Since April 1972 a modified windshield header molding and modified guide bearings have been installed in these vehicles.

Production Breakpoint

R 68/7611

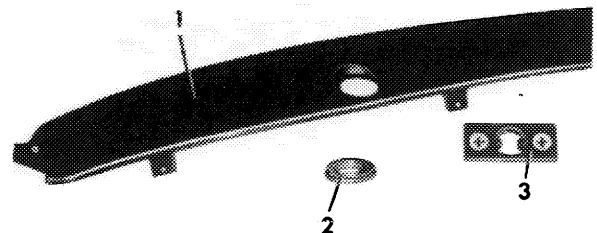
When installing the modified windshield header molding in vehicles with lower chassis end numbers, the two guide bearings and the two washers must also be replaced.

- 1 Unscrew windshield header molding (1) from front panel frame.
- 2 Remove both guide bearings.
